**RE: Lot 3 Block 3 Unit 22 SAD 228
6328 Camino Alto NW Volcano Cliffs Subdivision
Grading and Drainage Plan
Engineers Stamp Date; 1/9/19 (D10D003R3)
Pad Certification Date; 8/3/19
C.O. Certification Date; 5/15/2020**

Based upon the information provided in your submittal received 5/15 /2020, this plan is approved for Certificate of Occupancy release.

DRAINAGE AND TRANSPORTATION INFORMATION SHEET (REV 6/2018)

| | GRADING AND DRAINAGE PLAN | DATE |

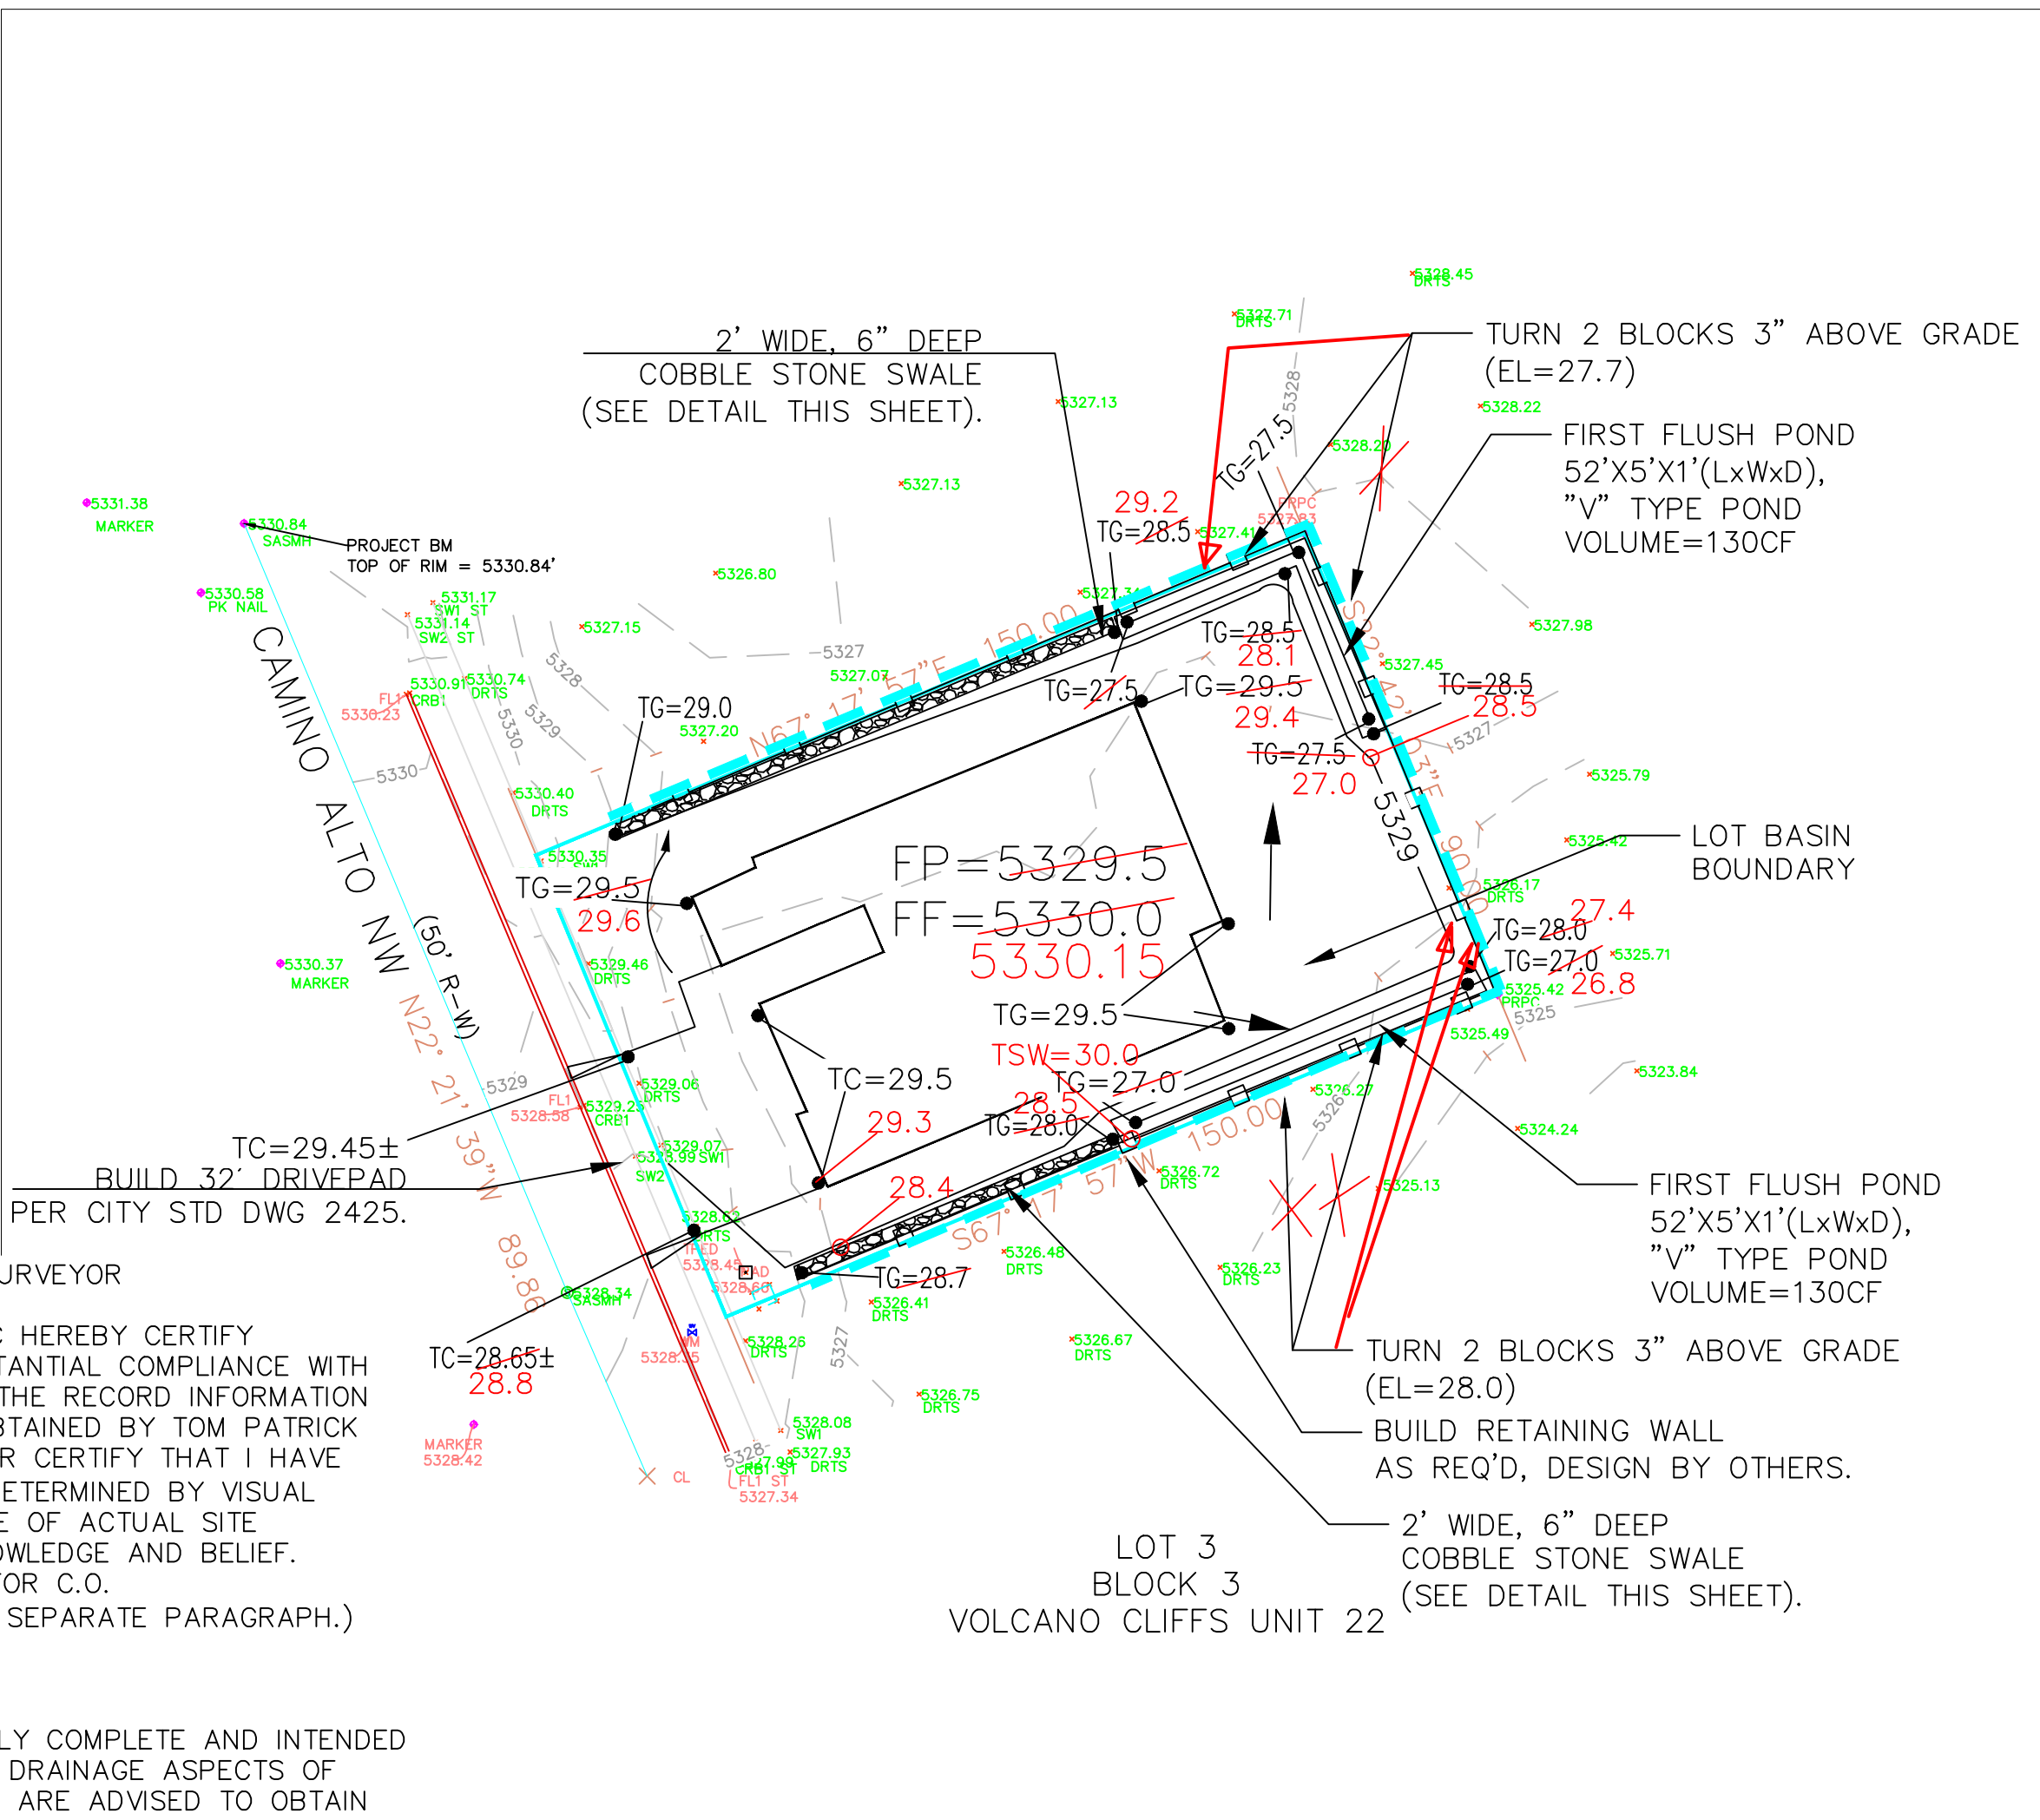
1. CHANGES SHOWN IN RED.
2. FIRST FLUSH POND ADJACENT TO REAR WALL.
